## Safety Recall Launch Notification

Campaign #	NHTSA ID	Description	<b>Rework Rear Headliner and C-Pillar Trim</b>
2025060004	25V379	25P6990005

# Recall Campaign Bulletin

CAMPAIGN NO.	2025060004
CAMPAIGN DESC.	25P6990005
NHTSA ID	25V379
SUBJECT	Rework Rear Headliner and C-Pillar Trim
MODEL(S)	GLC (254 platform)
MODEL YEAR(S)	2023 – 2025
CAMPAIGN POPULATION	92,851

**Figure 2 (Shown on left C-pillar trim element)**

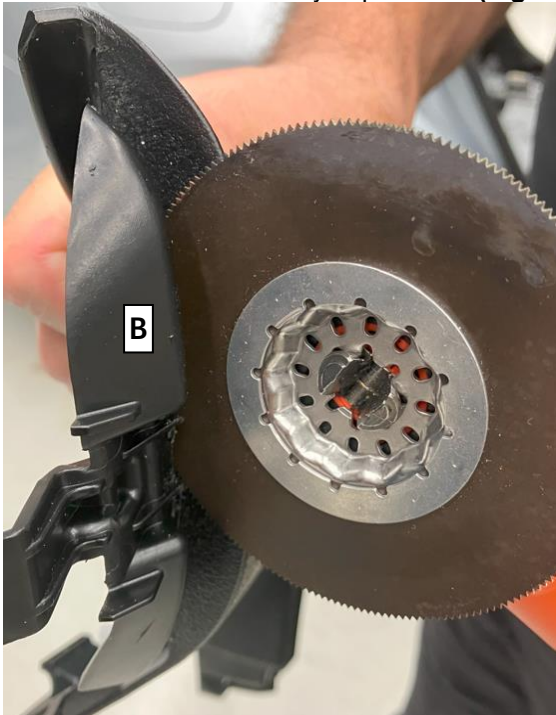
**Work Procedure 2:** Modify C-pillar trim (Figure 2, B) near the headliner contact area.

**Figure 3 (Cutting wire is 80 cm/31 inches in length)**

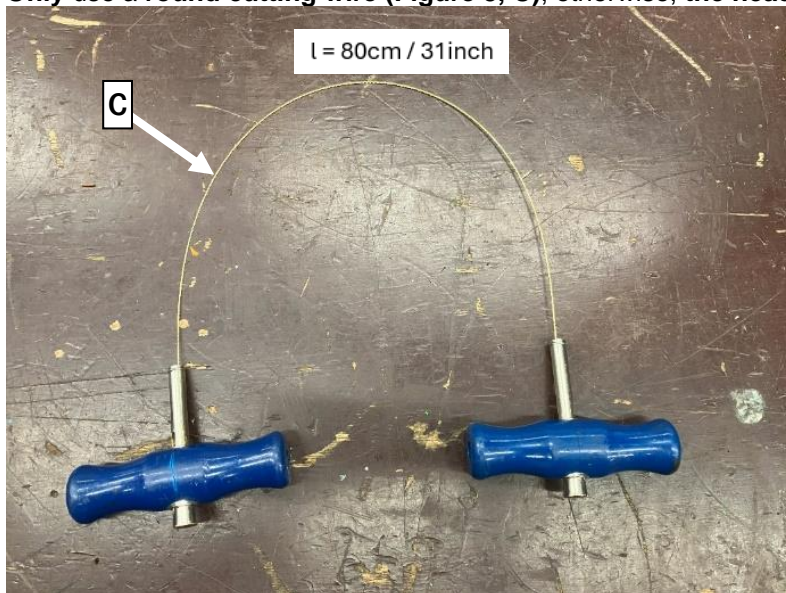
**i** The cutting tool is a commercially available tool for the removal of bonded vehicle windshields (Figure 3). **Only use a round cutting wire (Figure 3, C), otherwise, the headliner may be damaged!**

5. Clamp cutting wire (Figure 3, C) into grab handles as specified in the tool's instructions for use.
6. Lower the headliner in the C-pillar area **only far enough** to allow the cutting wire to be positioned correctly (Figure 4) on the foam block to be removed.

Figure 4 (Right side of vehicle, looking towards front passenger door)

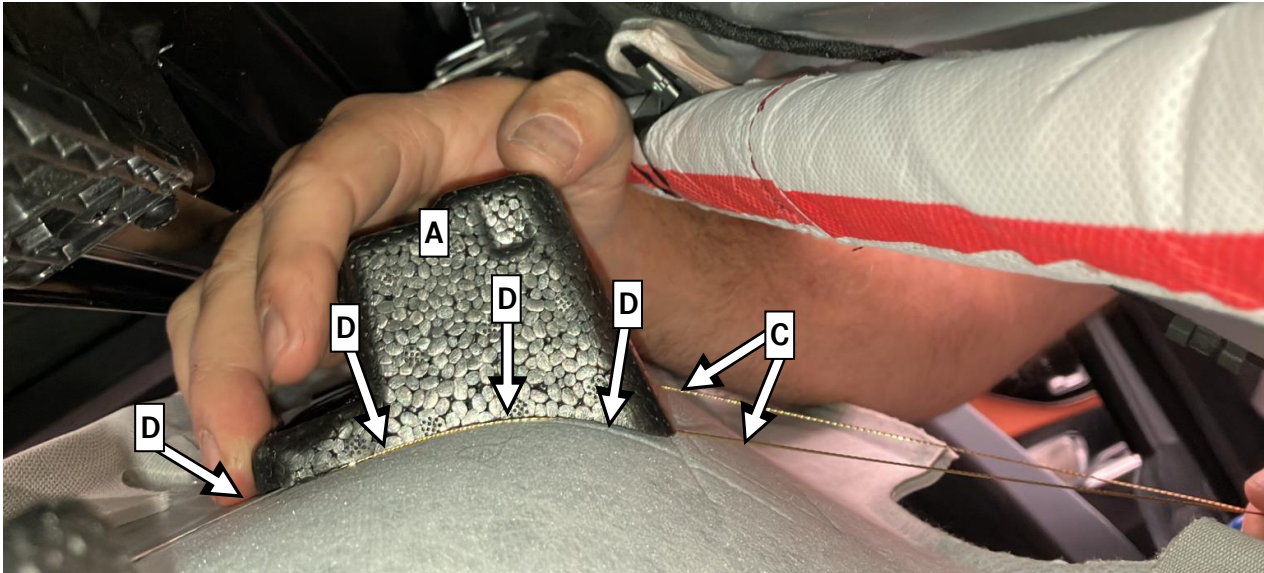
7. Position the cutting wire (**Figure 4, C**) around the foam block (**Figure 4, A**) so that the adhesive seam in the subsequent cutting procedure is cut **directly between** the headliner and the rigid foam block (**Figure 4, D**).

Figure 5 (Right side, looking towards left rear door, with roof lining partially lowered)

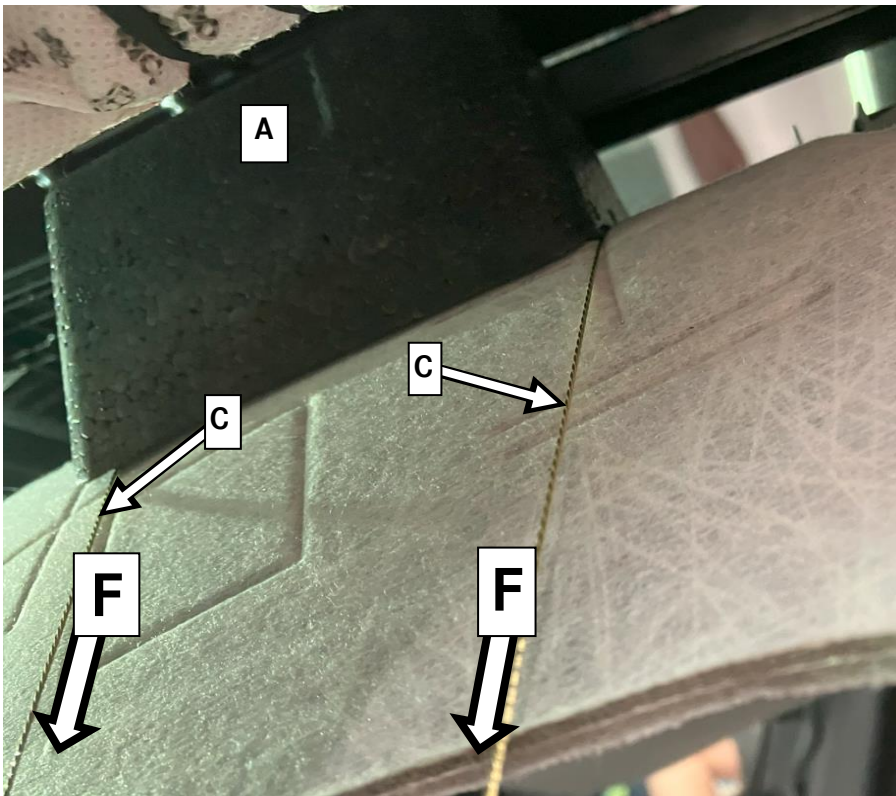
8. Perform cutting movements with the cutting wire (**Figure 5, C**) by pulling diagonally downward, parallel to the headliner. Observe path of cutting movement while cutting. Only pull (**Figure 5, F**) far enough to detach foam block (**Figure 5, A**) as **one whole piece** from headliner.

**i** Cut in a slow side-to-side motion to avoid heat development, while gently pulling diagonally down (**Figure 5, F**).

Figure 7 (Right C-pillar trim, front side)

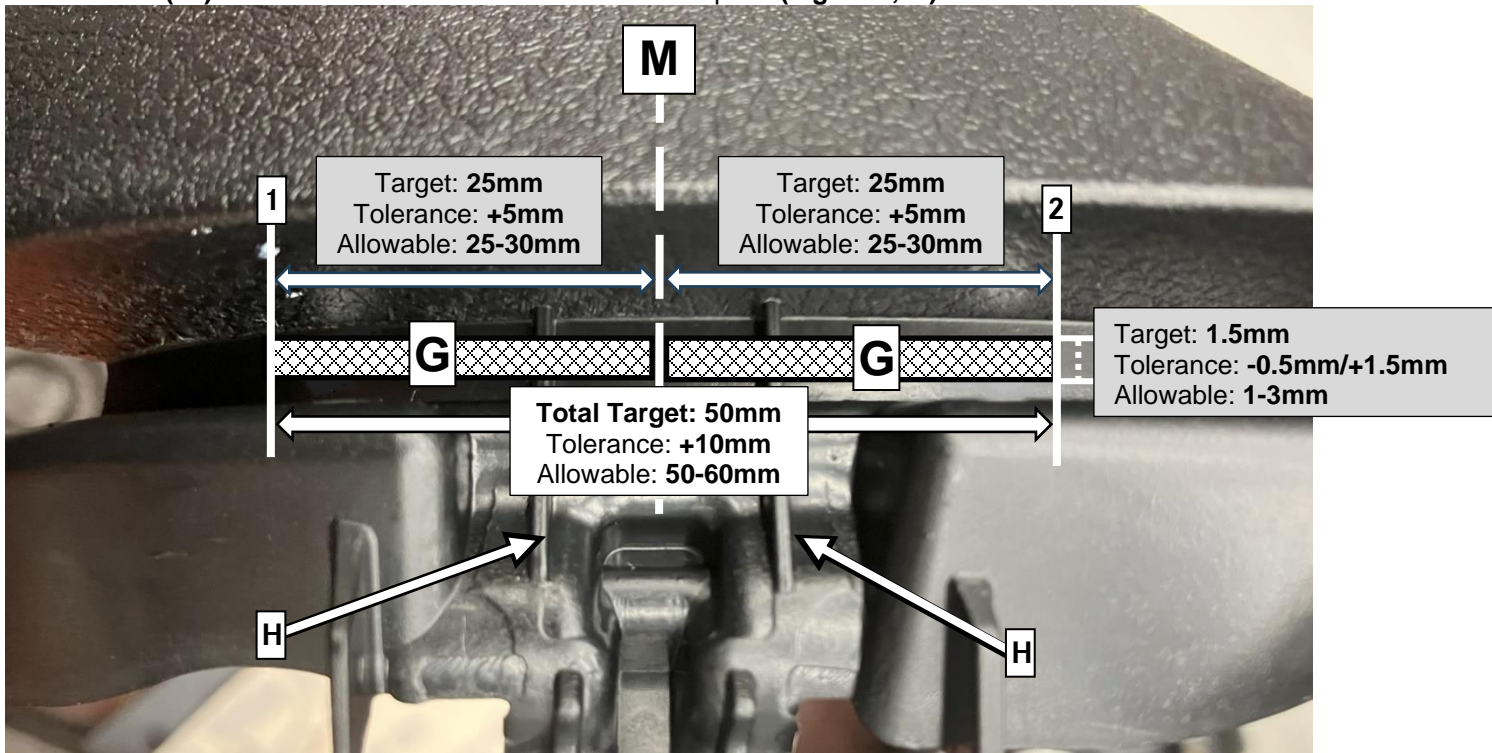
1. Use a silver or white permanent marker to mark cutting zone on C-pillar as shown in cross-hatched area (**Figure 7, G**). The horizontal length of the mark must be centered (**Figure 7, M**) between the molded material spines (**Figure 7, H**). The vertical height of the mark must be centered within the groove (**Figure 7, G**).

- i** Do not exceed a total cut length of 60mm and a total cut height of 3mm!  
 - 25(+5) mm allowable on each side of the central point (**Figure 7, M**)

Figure 9 (Measure and mark areas to cut)

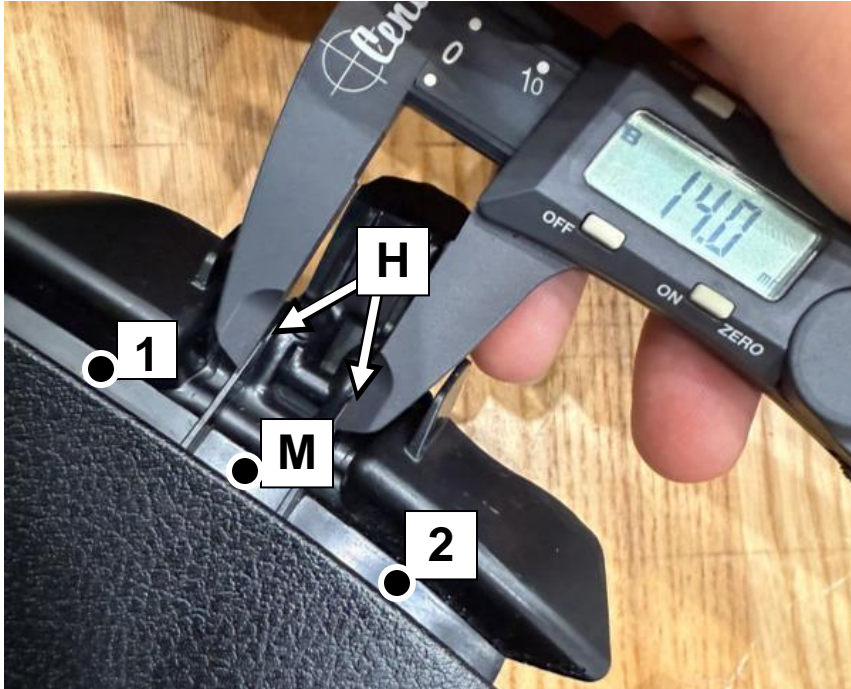
- On the front side of the C-pillar trim (interior facing), measure between the molded material spines (**Figure 9, H**) and mark the center point (**Figure 9, M**).

Figure 13 (Right C-pillar trim)

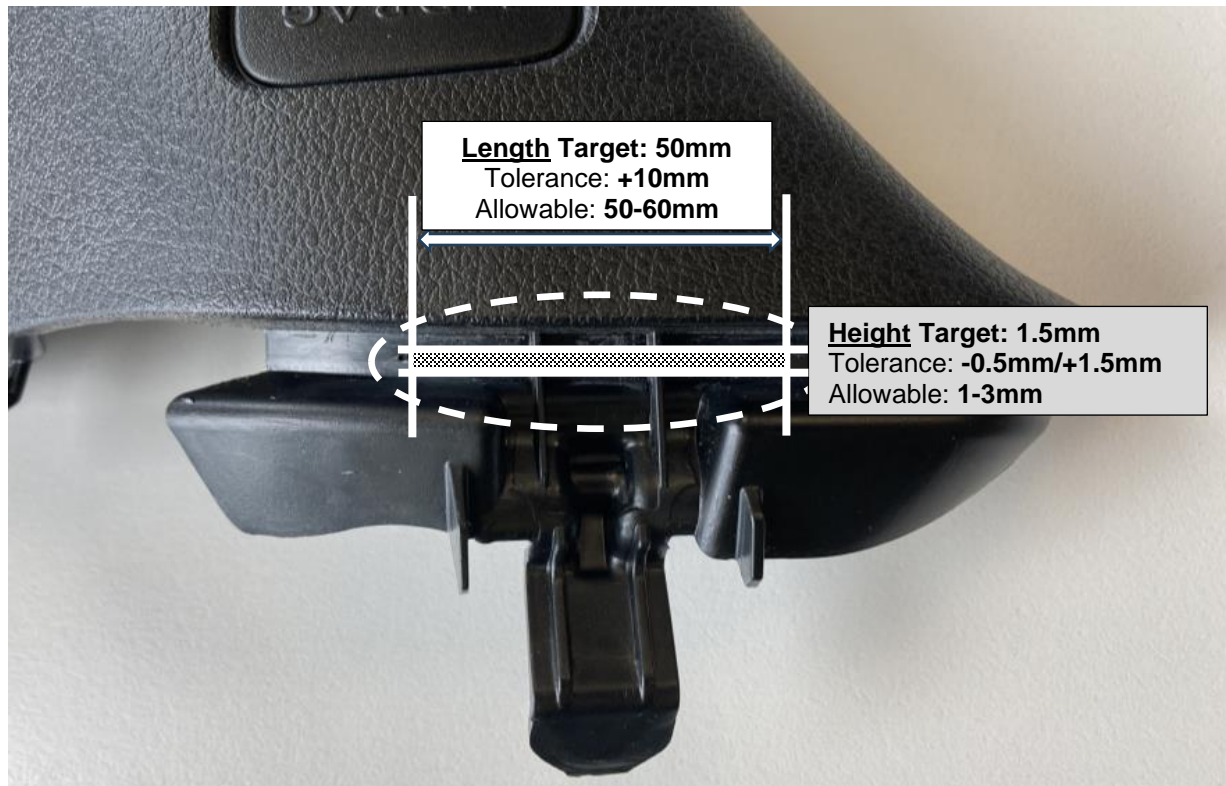
6. Check that the finished cut complies with the specified dimensions (**Figure 13**).

**i** The finished cut must be within the minimum and maximum specified dimensions.

**i** Ensure C-pillars on both sides of the vehicle (left and right) have been reworked to specified dimensions.
